# SES SOLAR ONE

In Response to CEC and BLM Data Requests  
49-70, 74, 75, 80, 82-84, and 86-91

Application for Certification (08-AFC-13)

RE: SES Solar One  
Applicant's Responses to CEC and BLM Data Requests Set 1, Part 1  
Data Requests 49-70, 74-75, 80, 82-84, and 86-91

**PROPOSED AND ALTERNATIVE SITING AREAS  
 SOLAR ONE PROJECT**

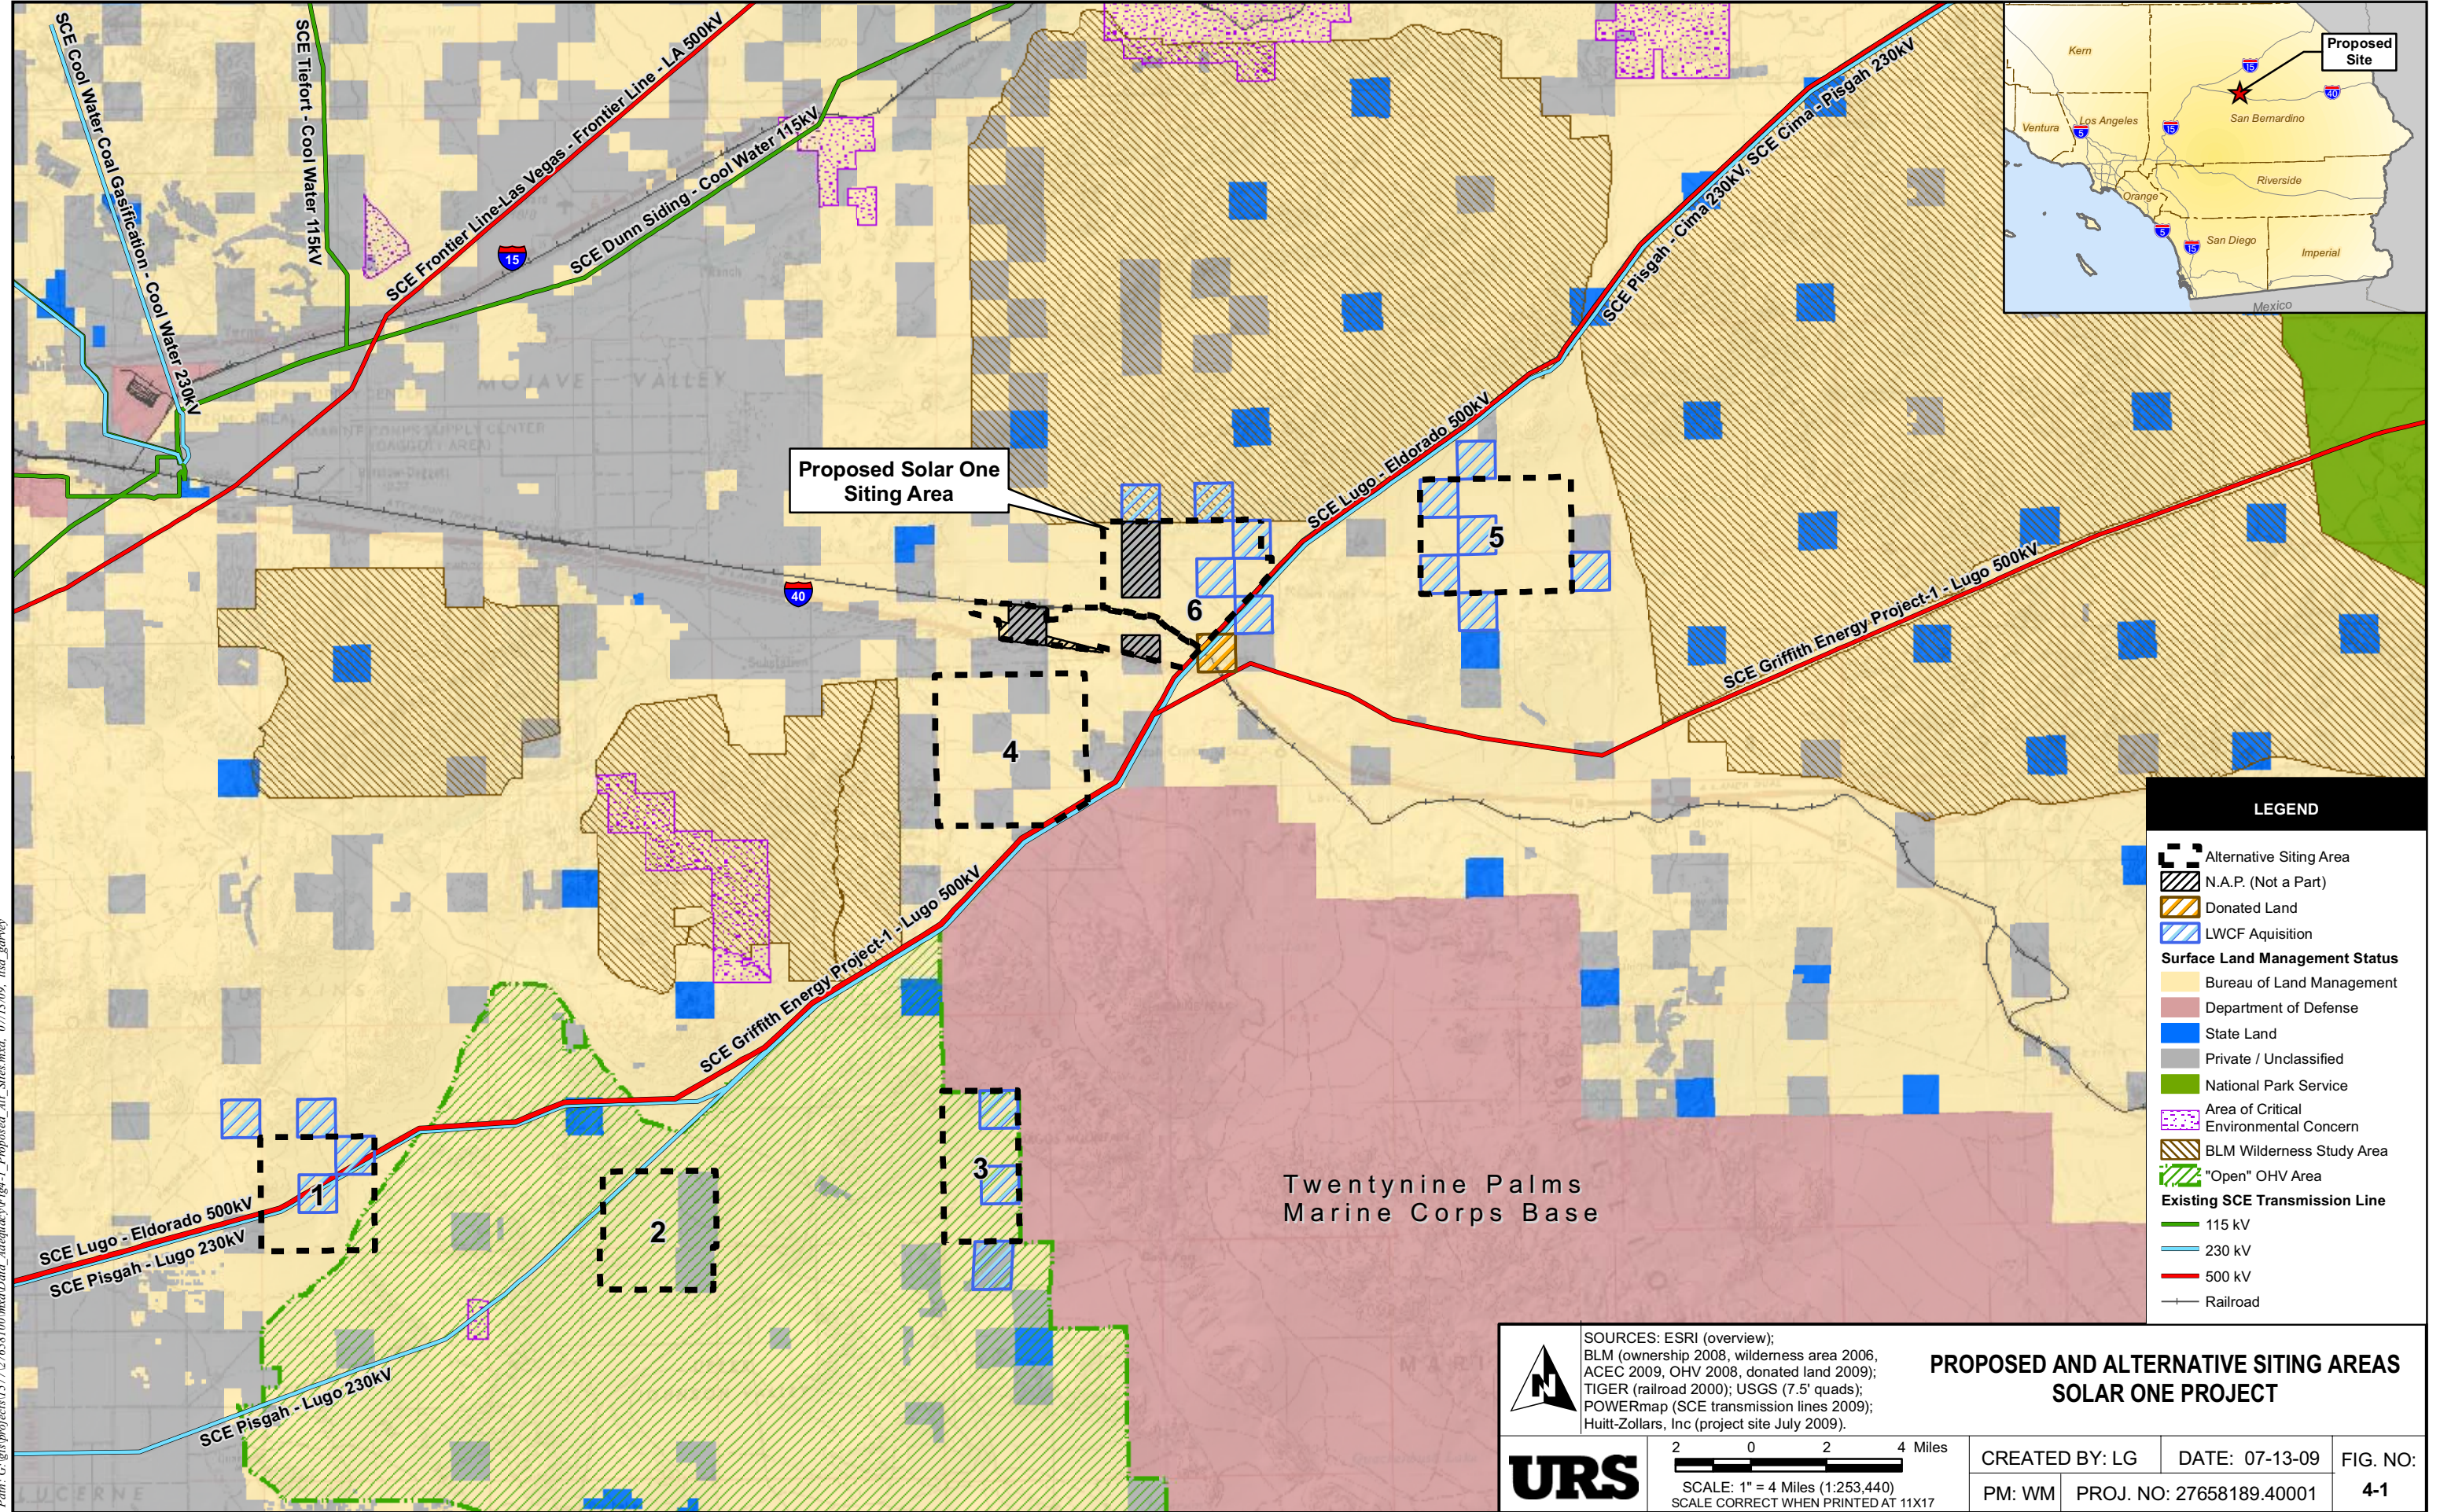
Please provide a revised Figure 4-1 that:

- Accurately reflects the project outline shown in Figure 1-2.
- Indicates what land within the project boundary is not currently considered part of the project.
- Identifies donated lands and lands acquired within LWCF funds within the project boundary and within any of the alternative sites depicted on Figure 4-1.

Figure 4-1 has been revised and is provided behind this response as attachment ALT-1.

Figure 1-7  
Hydrogen Gas Supply  
& Distribution

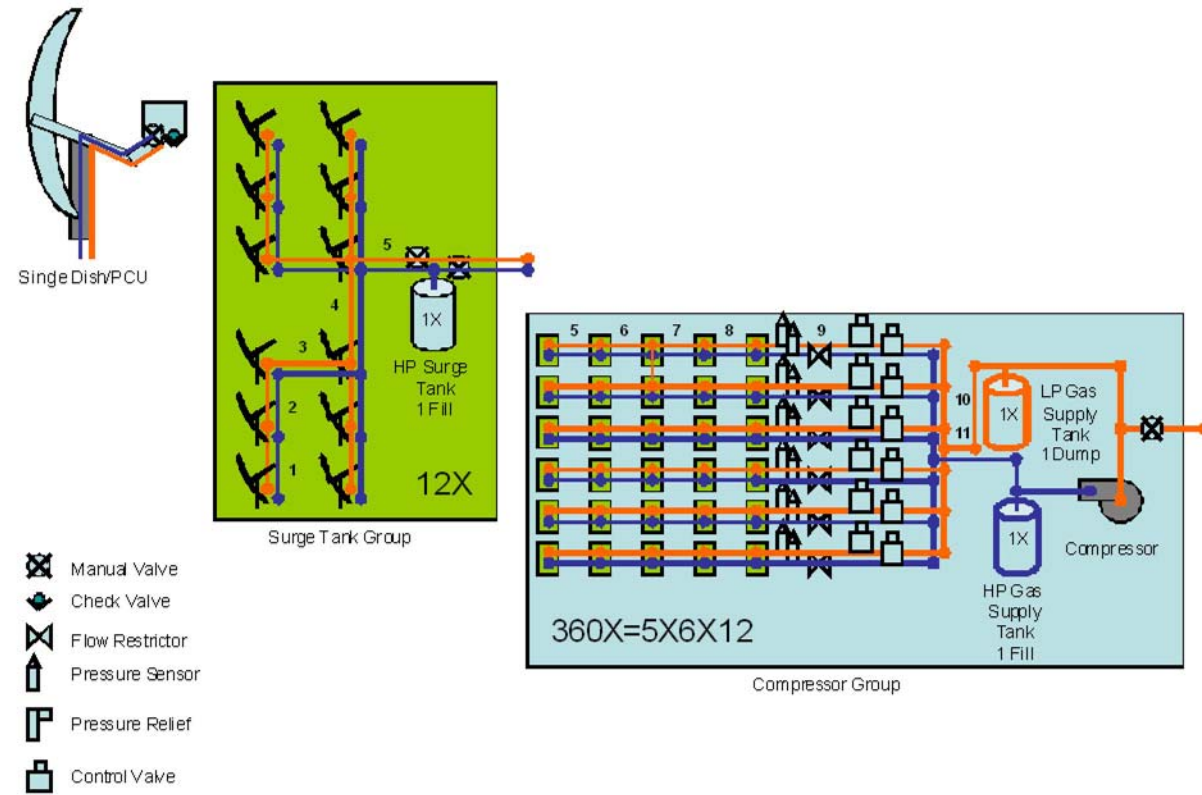
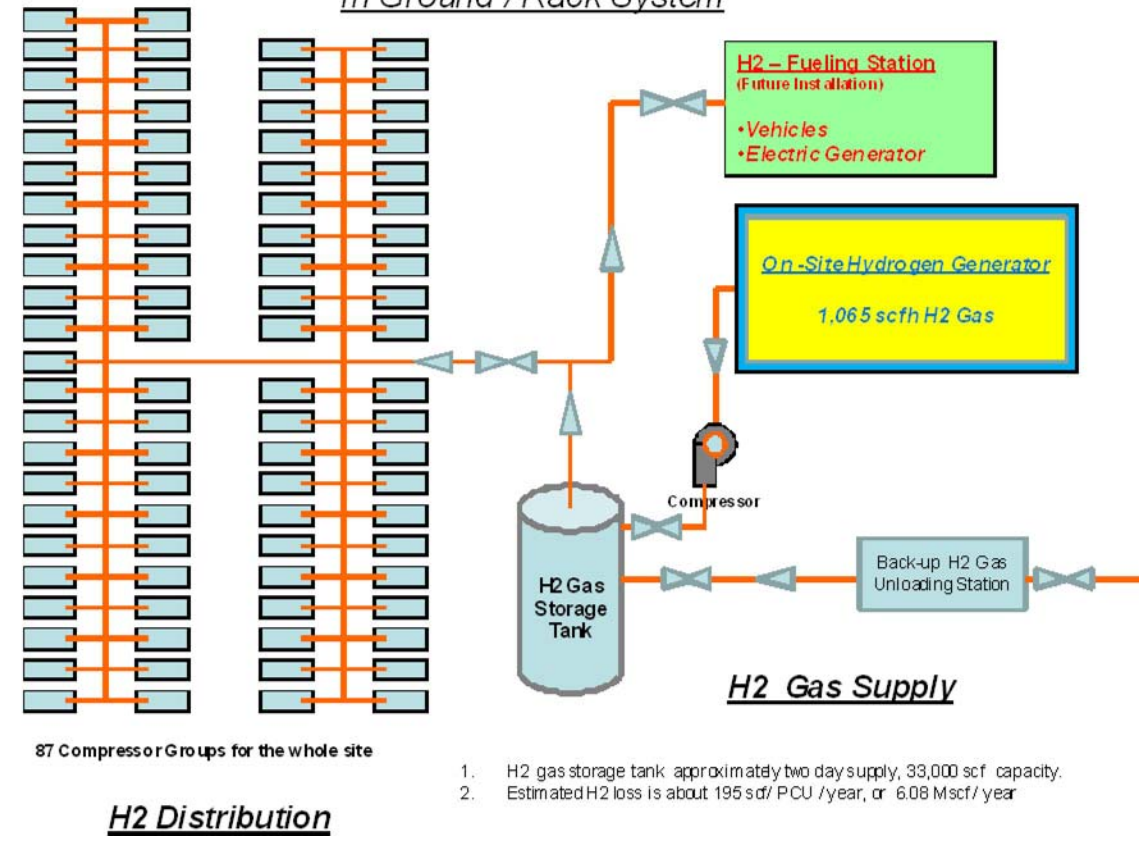
Please describe the source of hydrogen for the project, including a description of the process employed and the consumption of natural gas and/or electricity by that process.

K-Bottles will be provided by a commercial hydrogen supplier. If the Alternative Hydrogen Gas Supply and Distribution System is used, the hydrogen gas supply will come from two redundant hydrogen generators, each capable of producing 1,000 standard cubic feet per hour (scfh), requiring 146 watts/scf and 2.58 cubic inches of water/scf/hour of operation. Approximately 184 gallons of water per day will be required for these generators. The annual power consumption to meet the hydrogen production needs is 100.64 KWH, or 36.64 MW per year.

The hydrogen generator will run 24/7, or as needed, to provide the needed H<sub>2</sub> gas to support sun catcher's H<sub>2</sub> needs. Power consumption could be 24/7, based on the need of the hydrogen generators. However, these generators will normally be operated at off-peak electric hours using grid power. When running the unit at night, unit power will be provided from the grid.

Hydrogen generator requires 100 KWH to run; it will take 4 SunCatchers to support it if run during daylight hours. It will not diminish electrical delivery to SCE. H<sub>2</sub> will not be generated from natural gas. The hydrogen gas will be stored in a steel tank. The storage tank will be capable of storing approximately two day supply of hydrogen gas. This is described on attachment EFF-1 provided behind this Response.

**GROUNDWATER BASINS AND WELLS SOLAR ONE PROJECT**

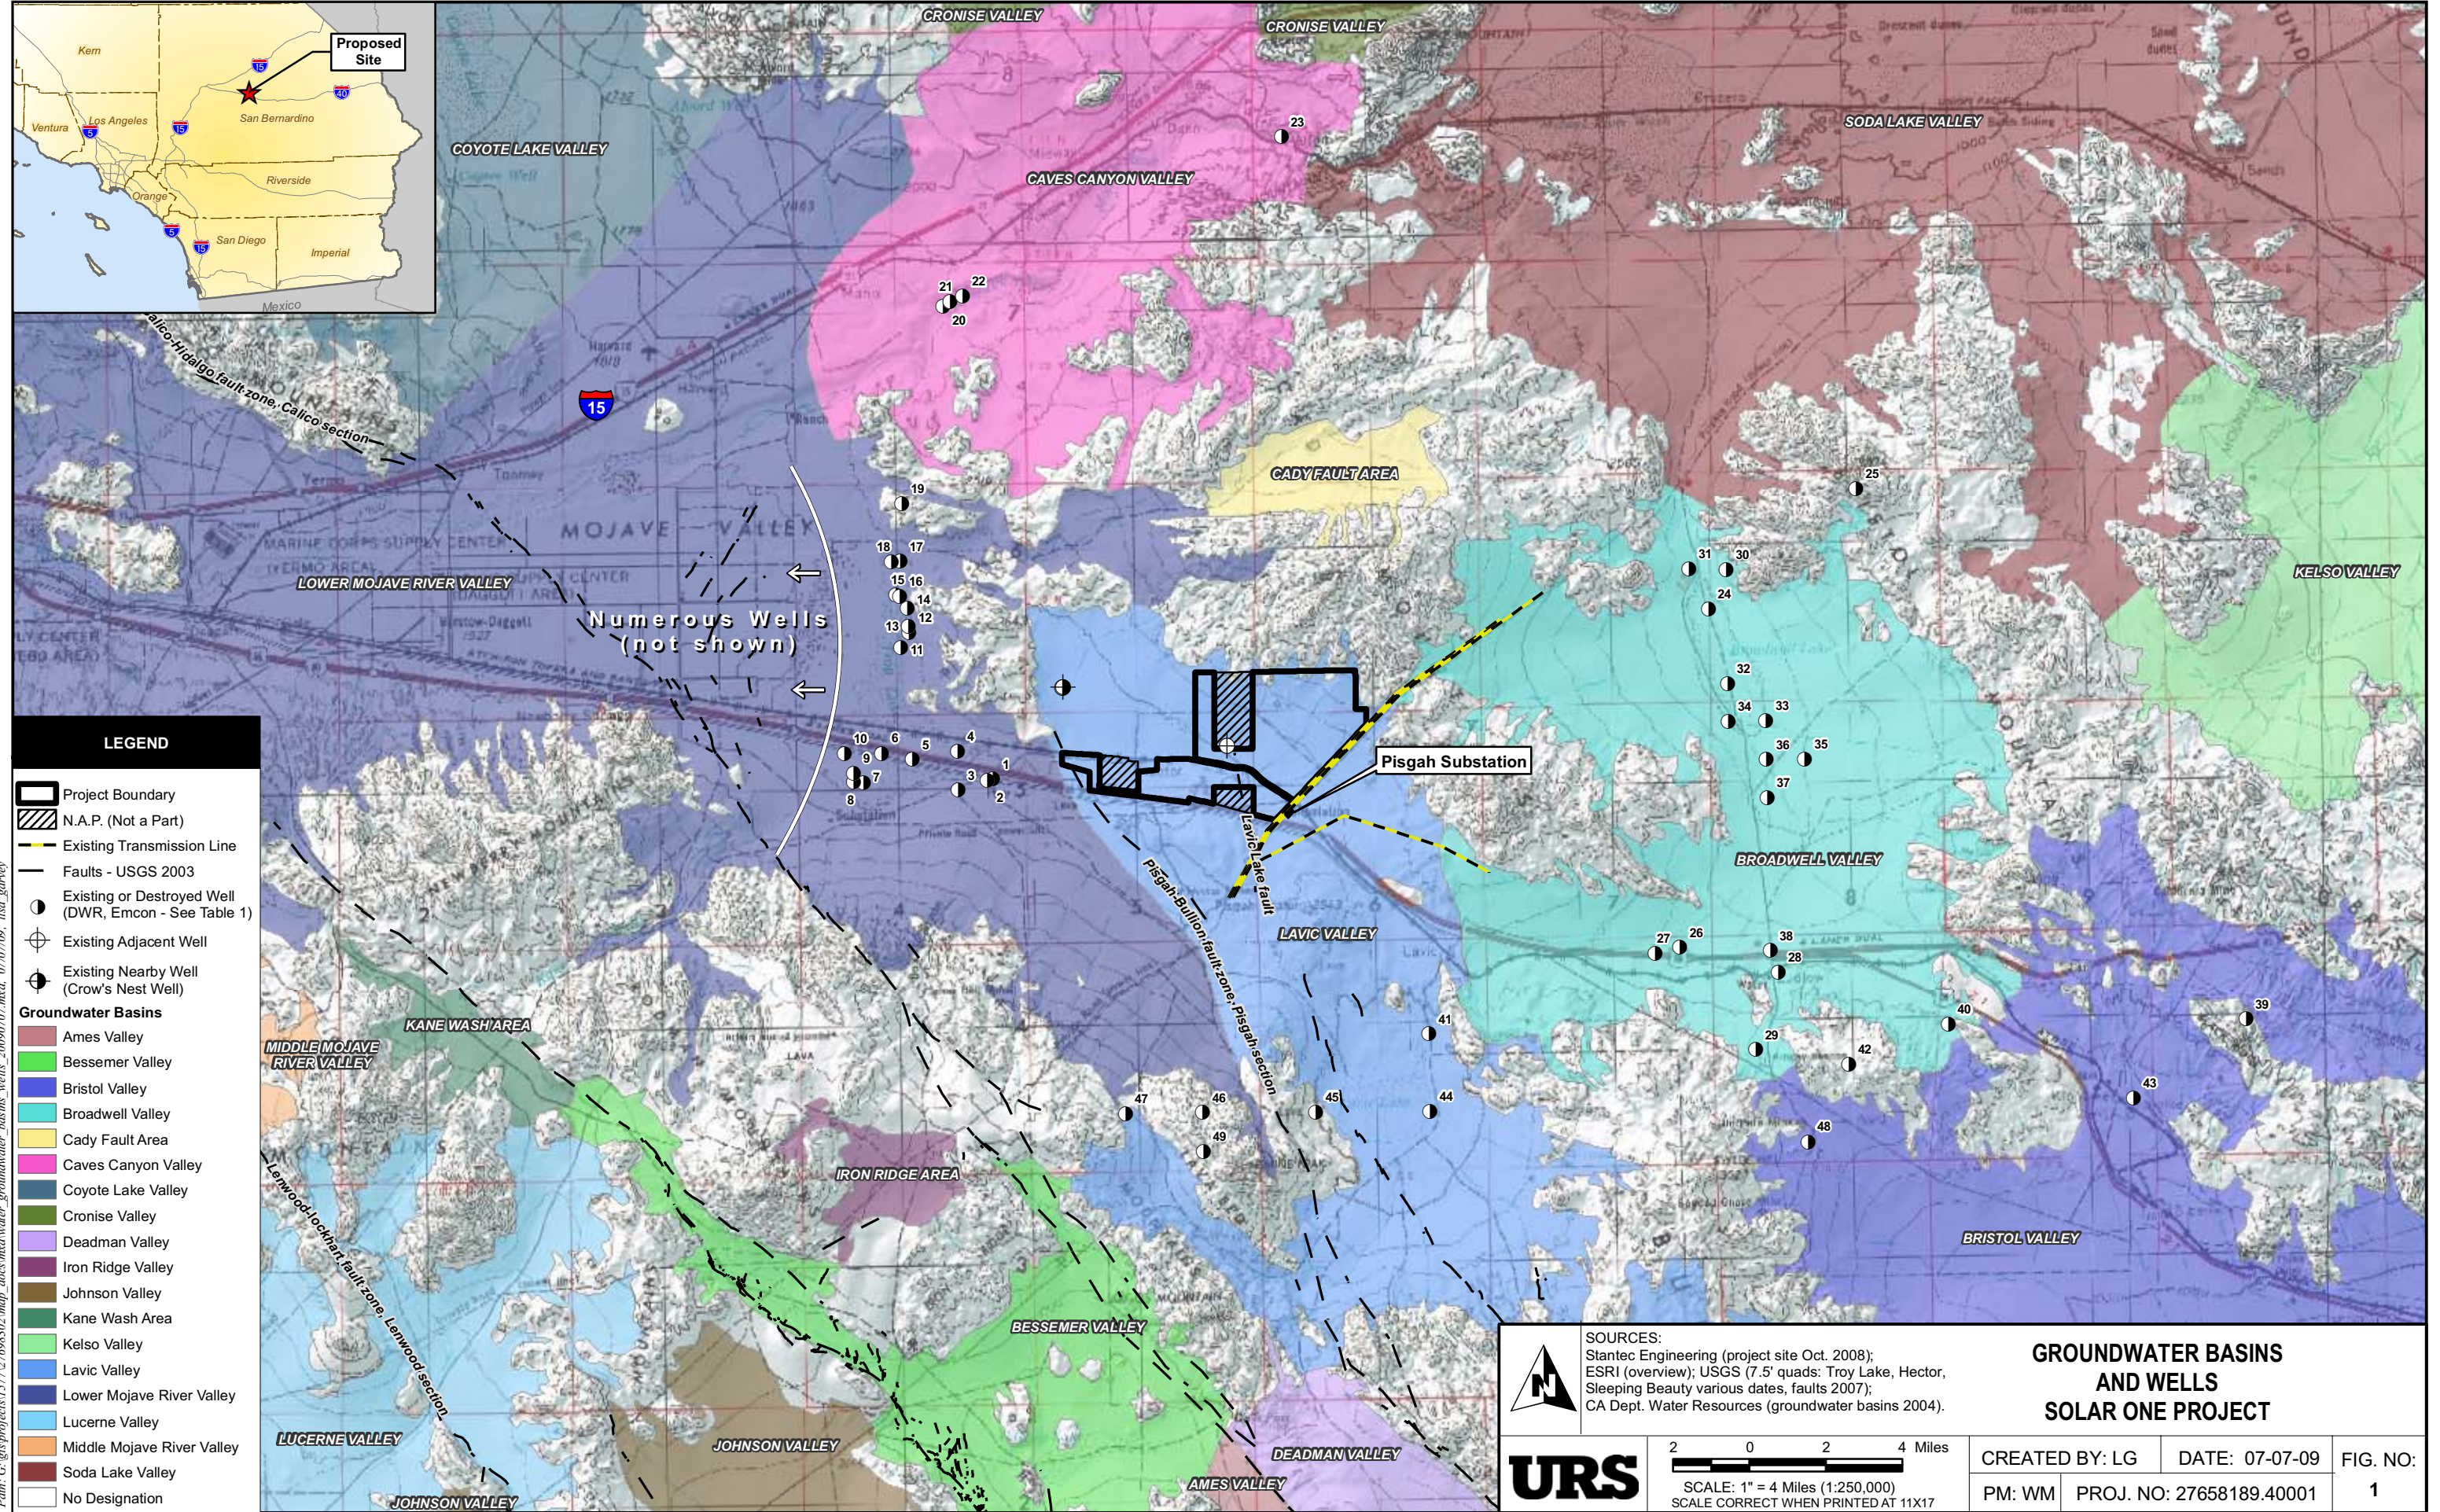
**Data Request 69:** Please clarify if the “adjacent well”, “nearby existing well” and the “Primary Water Well” are the same well or different wells.

**Response:** Each of these terms describes different wells. The well locations are shown on attachments SWR-1 and SWR-2. The terms are clarified as follows.

**Adjacent Well:** This well is located on private land that is not a part of the site (labeled on SWR-1 as Existing Adjacent Well). The depth to groundwater measured in 2008 in this wells was approximately 310 feet. The total well depth is approximately 320 feet.

**Nearby Existing Well:** According to the BLM, this well is called the Crow Nest Well. It is located on public land approximately 1.5 miles north of the westernmost point of the Project (labeled on SWR-1 as Existing Nearby Well). This well was reported to be approximately 170 feet deep and historically used to support the grazing of livestock and was associated with two 4,500-gallon above ground water tanks (Rotte 2008). URS measured depth to water in this well to be about 130 feet and the total well depth to be approximately 138 feet. Well completion reports are not available from DWR or San Bernardino County for either the adjacent or nearby existing well.

There are other wells documented in the site vicinity, but these are located more than 1 mile from the site. These wells are shown on SWR-1.
